MODIFICATION 01 - JUNE 2020
SCHEDULE OF CHANGES

MOD2020/0334

PROJECT
32 The Strand
Whale Beach, NSW, 2107
Lot 70 on DP11067

PHASE
DA
DWG NO
210.01
REV
C
schematic design

DRAWING NAME
floor plans
roof plan

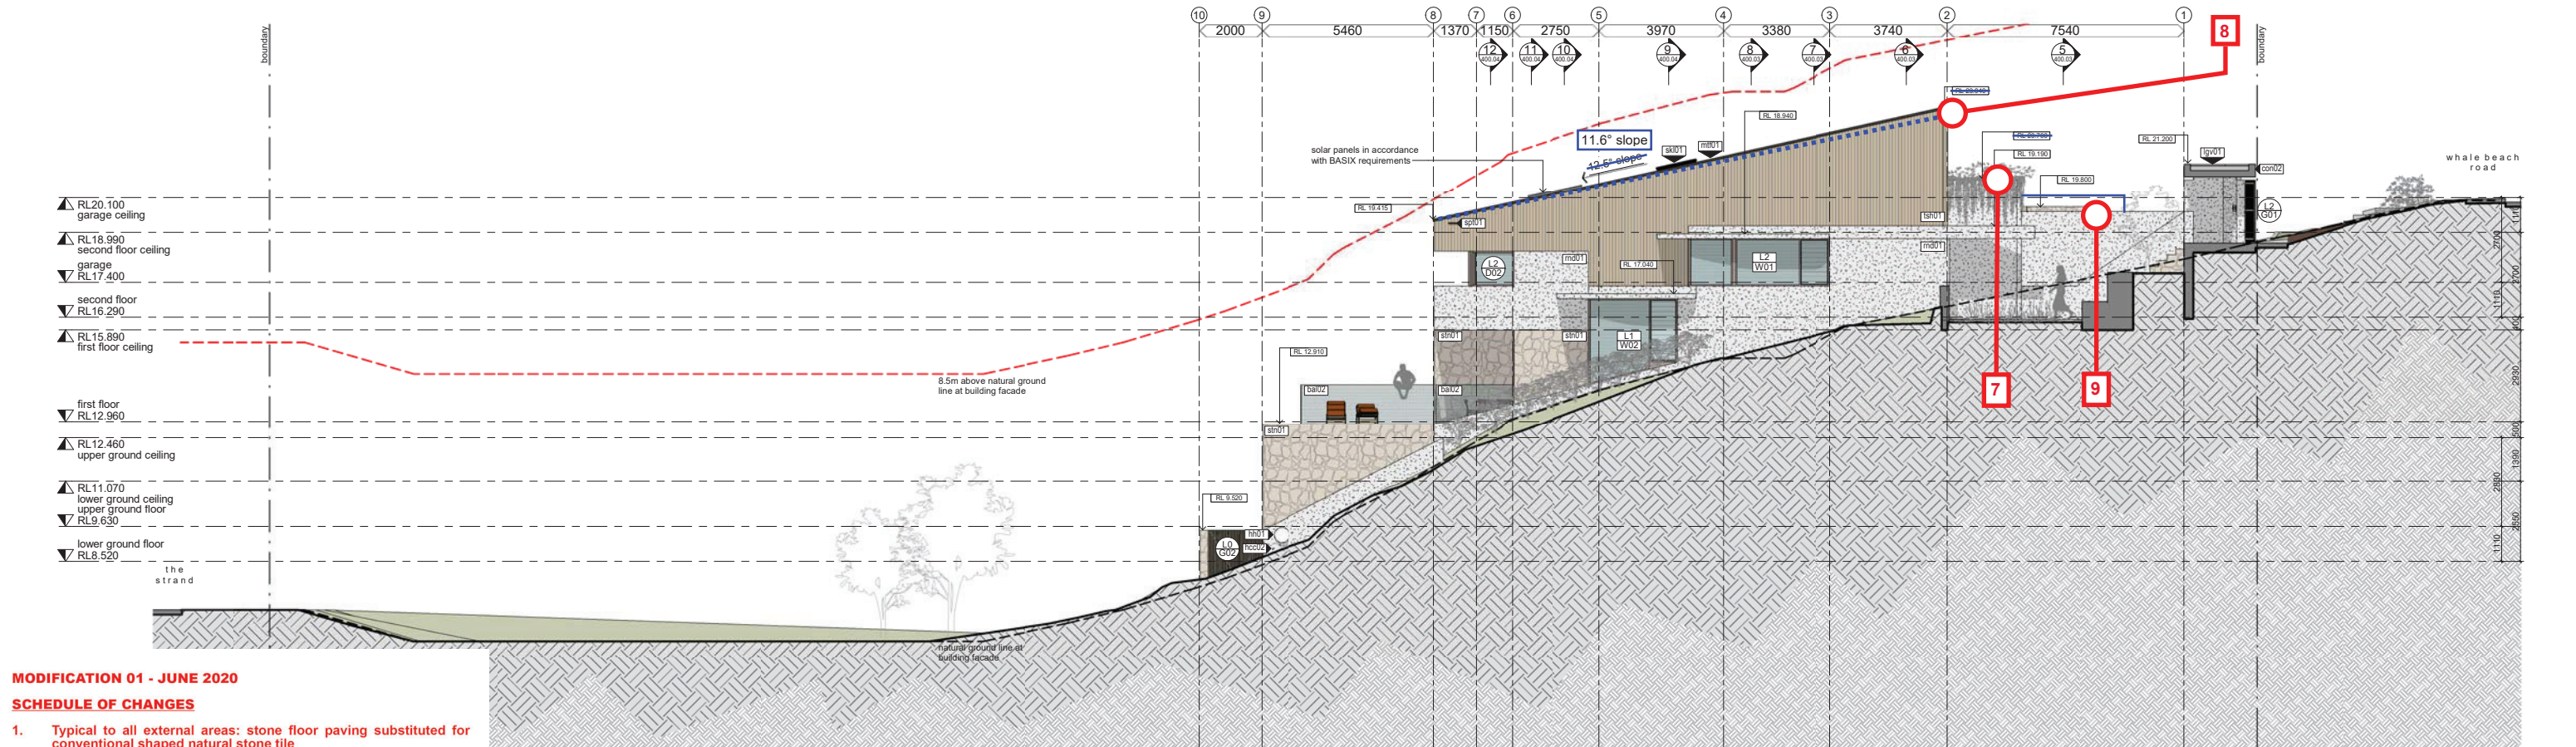
- Typical to all external areas: stone floor paving substituted for conventional shaped natural stone tile
- Typical to all internal areas: stone floor paving substituted for timber floors, and conventional shaped natural stone tiles in wet areas

- Hard path and steps removed from architectural scope. Soft landscaping solution by landscape architect
- Driveway finish changed and widened in accordance with consent SL2020/0241

- Driveway levels modified to suit Council requirements in accordance with consent SL2020/0241. Car turntable added
- Garage level raised by 300mm to RL17.700 as a result of accommodating [5]

- Garage roof and garden edge lifted 150mm to RL20.850 as a result of accommodating [5] and [6].
- Main roof ridge lowered by 290mm to RL22.750 as a courtesy to improve the view amenity of a neighbour to the west. Roof slope adjusted to 11.6 degrees.

- Bin store reshaped and curved wall deleted. Bin store lid level shown at RL20.150. Refer to plans for dims where appropriate. Alteration in part as a result of compliance with prescribed conditions of consent (23) + (25) relating to tree protection and arborist's recommendations.

- Minor alteration to configuration of glazing. Fixed glass to study. Glazed swing door out of laundry. Note net area and amount of glass remains unchanged.

- Minor alteration to configuration of glazing. Refer to plan for relocation of walls. Note net area and amount of glass remains unchanged. floor area slightly reduced.

- Swimming pool infinity edges (and associated ballast tank) deleted and zone changed to accessible path and landscaped wall/planter
- Steps introduced to pool terrace to access service path. Refer to plans for dims where appropriate.

- Extra solar panels added to increase energy efficiency of development
- Block wall moved down to align with pool equipment adjacent as shown. Note this change is underground and not visible to the public or neighbours.

- Plant and equipment store area increased by moving western wall further west in order to accommodate the required equipment with ventilation and service space. Refer to plans for dims where appropriate.

- Block wall to be changed to screening for ventilation and sound attenuation
- Seat added
- Landscape plan amended in accordance with prescribed conditions of consent (15) + (38).

- Height of landscaped wall facing street to be increased to the North to a max height of 1800mm above ground level to follow natural topography.

2 east elevation
1:100

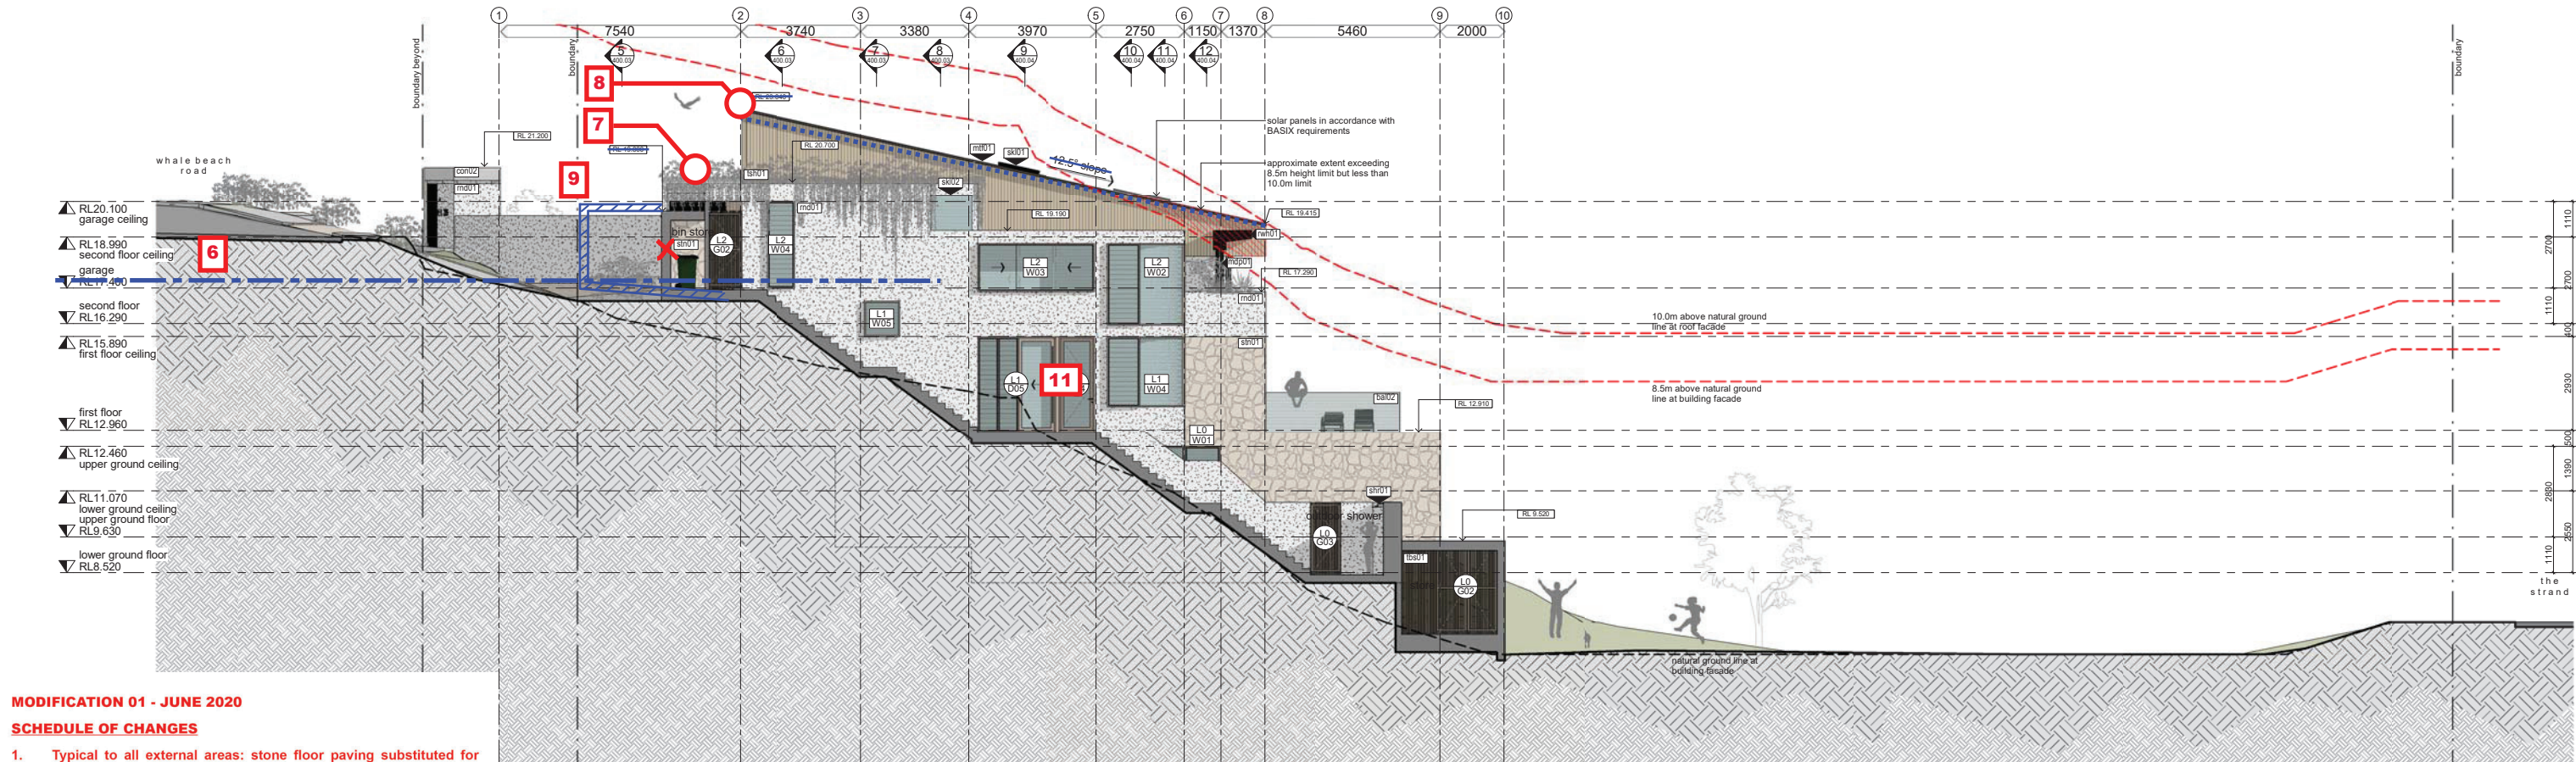
- Typical to all external areas: stone floor paving substituted for conventional shaped natural stone tile
- Typical to all internal areas: stone floor paving substituted for timber floors, and conventional shaped natural stone tiles in wet areas

- Hard path and steps removed from architectural scope. Soft landscaping solution by landscape architect
- Driveway finish changed and widened in accordance with consent SL2020/0241

- Driveway levels modified to suit Council requirements in accordance with consent SL2020/0241. Car turntable added
- Garage level raised by 300mm to RL17.700 as a result of accommodating [5]

- Garage roof and garden edge lifted 150mm to RL20.850 as a result of accommodating [5] and [6].
- Main roof ridge lowered by 290mm to RL22.750 as a courtesy to improve the view amenity of a neighbour to the west. Roof slope adjusted to 11.6 degrees.

- Bin store reshaped and curved wall deleted. Bin store lid level shown at RL20.150. Refer to plans for dims where appropriate. Alteration in part as a result of compliance with prescribed conditions of consent (23) + (25) relating to tree protection and arborist's recommendations.

- Minor alteration to configuration of glazing. Fixed glass to study. Glazed swing door out of laundry. Note net area and amount of glass remains unchanged.

- Minor alteration to configuration of glazing. Refer to plan for relocation of walls. Note net area and amount of glass remains unchanged. floor area slightly reduced.

- Swimming pool infinity edges (and associated ballast tank) deleted and zone changed to accessible path and landscaped wall/planter
- Steps introduced to pool terrace to access service path. Refer to plans for dims where appropriate.

- Extra solar panels added to increase energy efficiency of development
- Block wall moved down to align with pool equipment adjacent as shown. Note this change is underground and not visible to the public or neighbours.

- Plant and equipment store area increased by moving western wall further west in order to accommodate the required equipment with ventilation and service space. Refer to plans for dims where appropriate.

- Block wall to be changed to screening for ventilation and sound attenuation
- Seat added
- Landscape plan amended in accordance with prescribed conditions of consent (15) + (38).

- Height of landscaped wall facing street to be increased to the North to a max height of 1800mm above ground level to follow natural topography.

2 west elevation
1:100

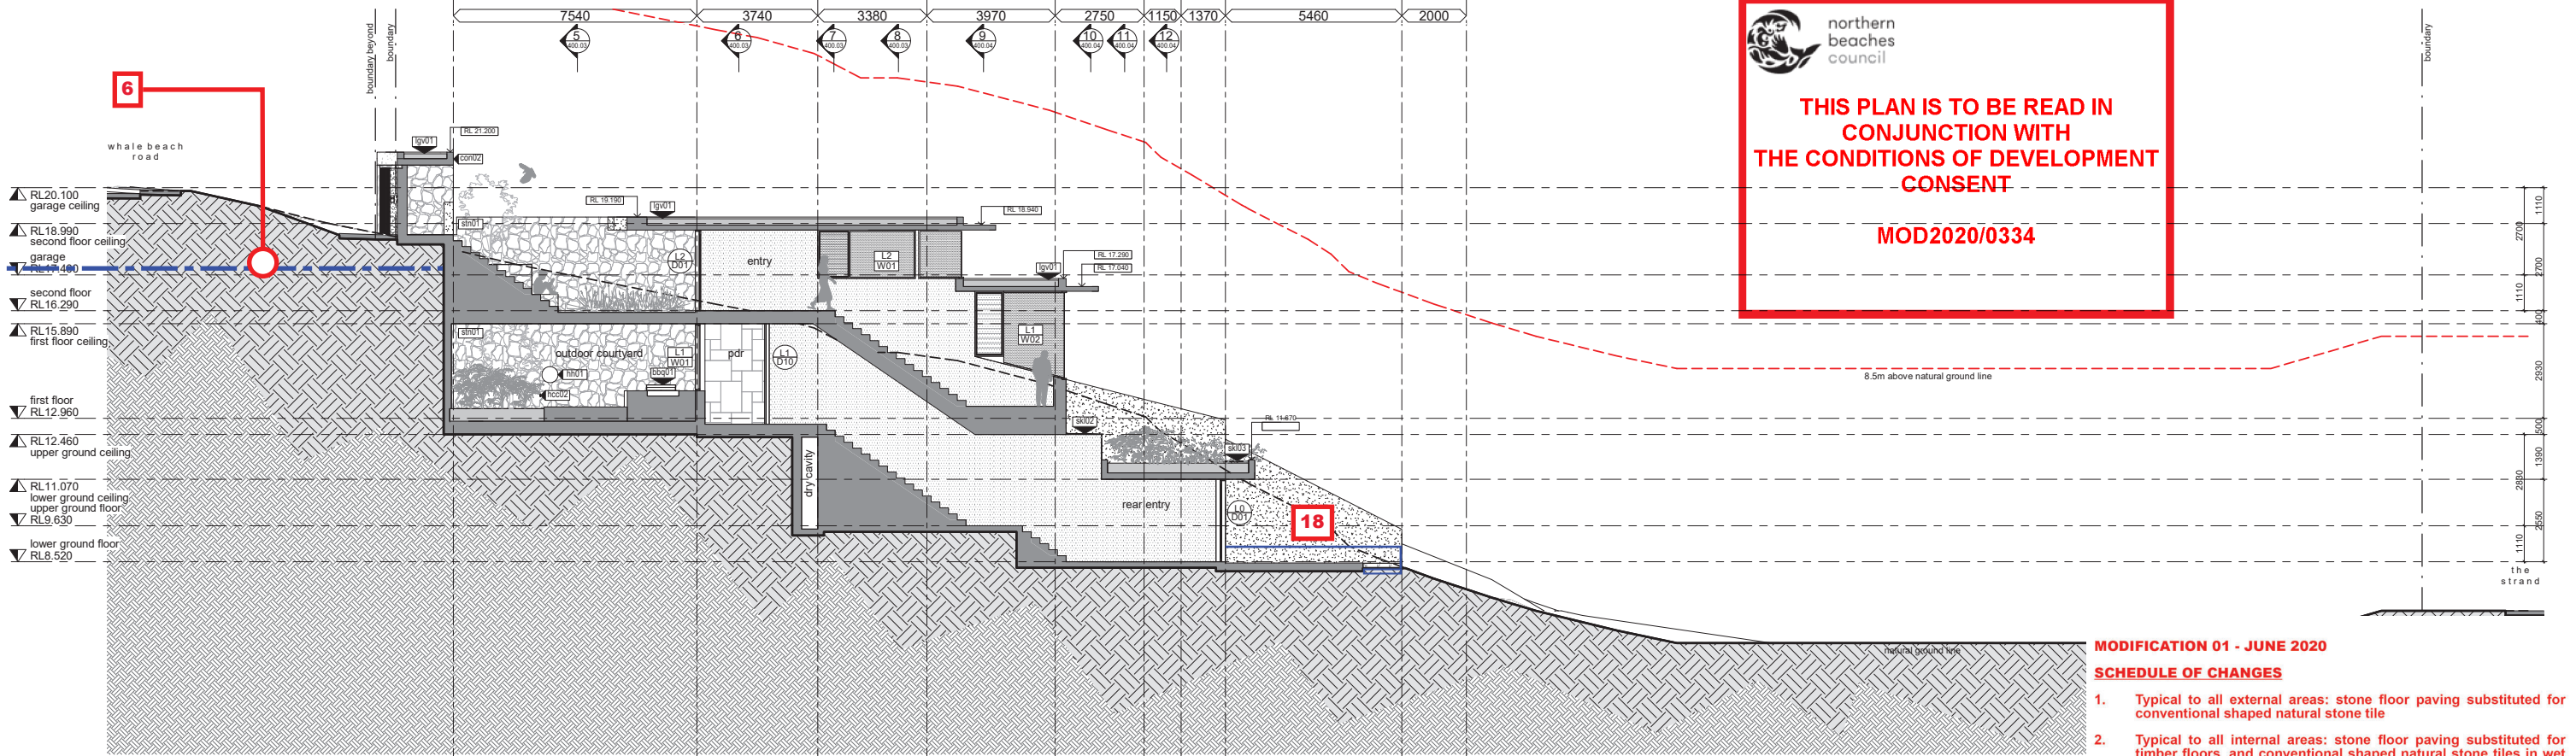
1. Typical to all external areas: stone floor paving substituted for conventional shaped natural stone tile
2. Typical to all internal areas: stone floor paving substituted for timber floors, and conventional shaped natural stone tiles in wet areas

3. Hard path and steps removed from architectural scope. Soft landscaping solution by landscape architect
4. Driveway finish changed and widened in accordance with consent SL2020/0241

5. Driveway levels modified to suit Council requirements in accordance with consent SL2020/0241. Car turntable added
6. Garage level raised by 300mm to RL17.700 as a result of accommodating [5]

7. Garage roof and garden edge lifted 150mm to RL20.850 as a result of accommodating [5] and [6].
8. Main roof ridge lowered by 290mm to RL22.750 as a courtesy to improve the view amenity of a neighbour to the west. Roof slope adjusted to 11.6 degrees.

9. Bin store reshaped and curved wall deleted. Bin store lid level shown at RL20.150. Refer to plans for dims where appropriate. Alteration in part as a result of compliance with prescribed conditions of consent (23) + (25) relating to tree protection and arborist's recommendations.

10. Minor alteration to configuration of glazing. Fixed glass to study. Glazed swing door out of laundry. Note net area and amount of glass remains unchanged.

11. Minor alteration to configuration of glazing. Refer to plan for relocation of walls. Note net area and amount of glass remains unchanged. floor area slightly reduced.

12. Swimming pool infinity edges (and associated ballast tank) deleted and zone changed to accessible path and landscaped wall/planter
13. Steps introduced to pool terrace to access service path. Refer to plans for dims where appropriate.

14. Extra solar panels added to increase energy efficiency of development
15. Block wall moved down to align with pool equipment adjacent as shown. Note this change is underground and not visible to the public or neighbours.

16. Plant and equipment store area increased by moving western wall further west in order to accommodate the required equipment with ventilation and service space. Refer to plans for dims where appropriate.

17. Block wall to be changed to screening for ventilation and sound attenuation
18. Seat added
19. Landscape plan amended in accordance with prescribed conditions of consent (15) + (38).

20. Height of landscaped wall facing street to be increased to the North to a max height of 1800mm above ground level to follow natural topography.
